**EASTLAND COUNTY WATER SUPPLY DISTRICT
WATER SYSTEM IMPROVEMENTS
CONTRACT K – FACILITY SUPPORT
TEXAS WATER DEVELOPMENT BOARD (TWDB) DWSRF**

Addendum No. 2

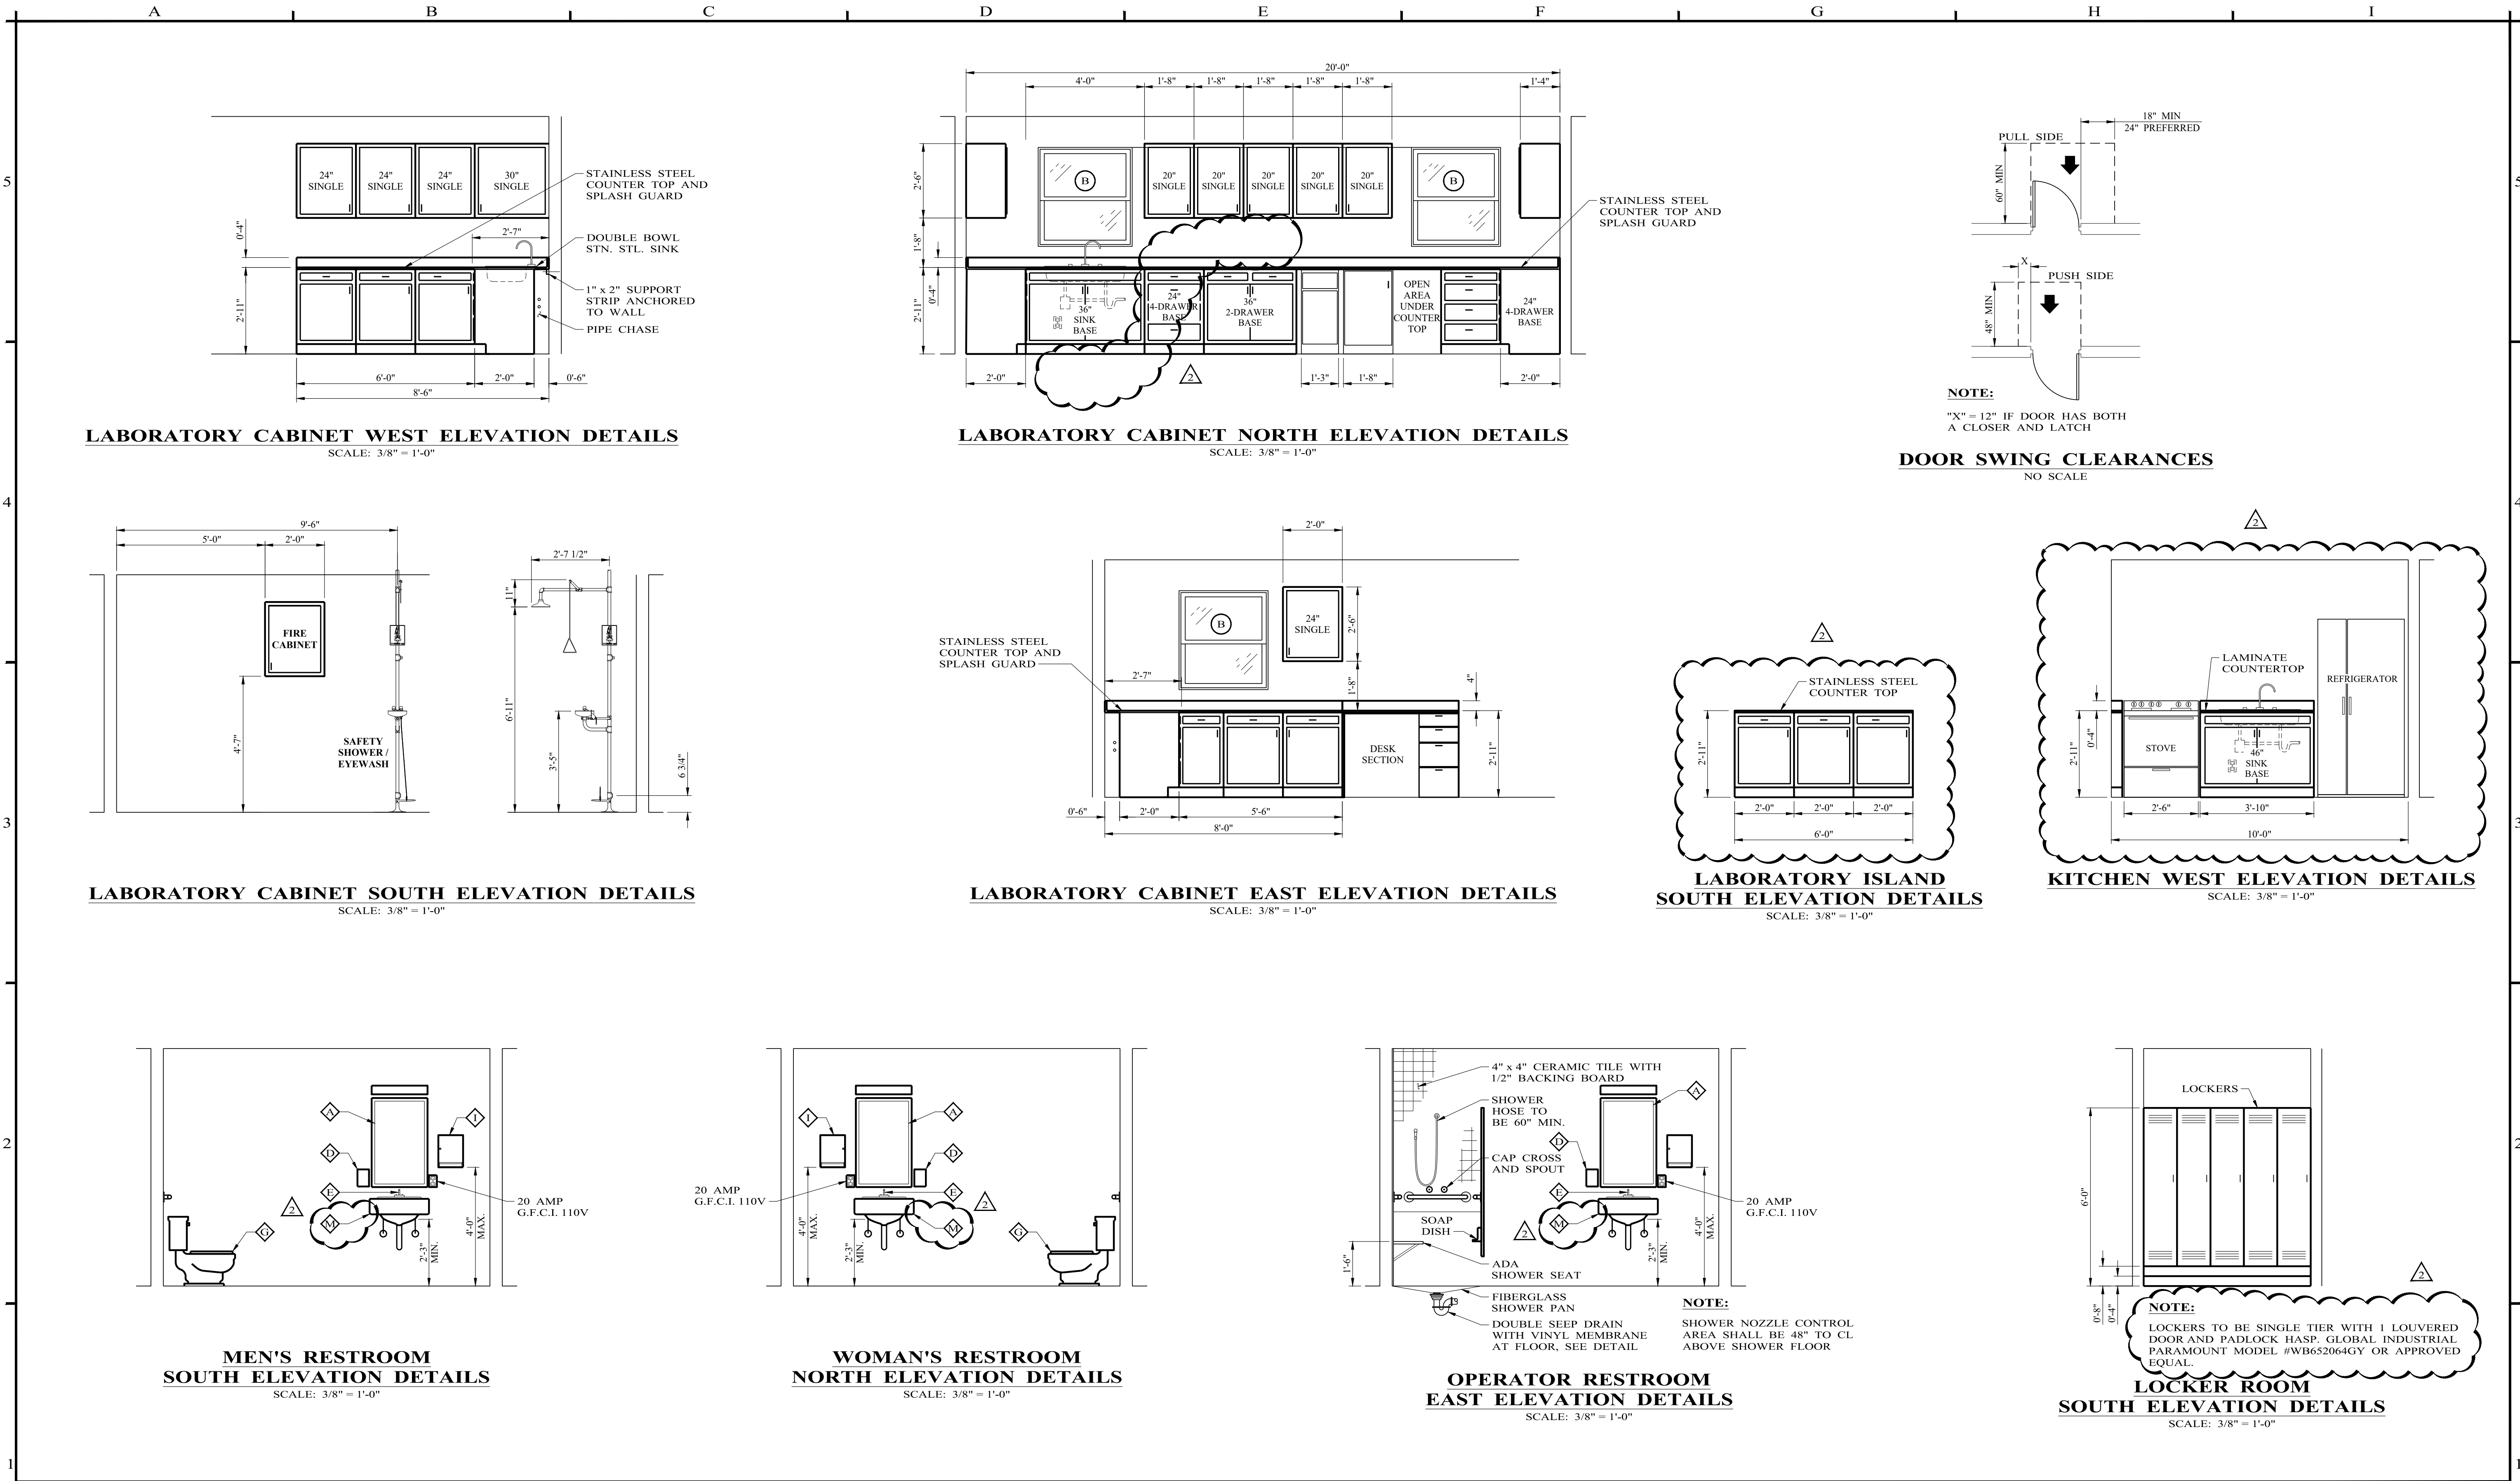
1. **REPLACE** Sheet G-001 in its entirety. See the attached.
2. **REPLACE** Sheet A-803 in its entirety. See the attached.
3. **REPLACE** Sheet A-805 in its entirety. See the attached.
4. **REMOVE** Specification 12122 reference from sheet A-800.
5. **REMOVE** Detail F on sheet C-012. Use detail E for access road.
6. Sheet M-201, EF-5 to be **RELOCATED** to the break room on the Southwest corner of the building over the stove area.
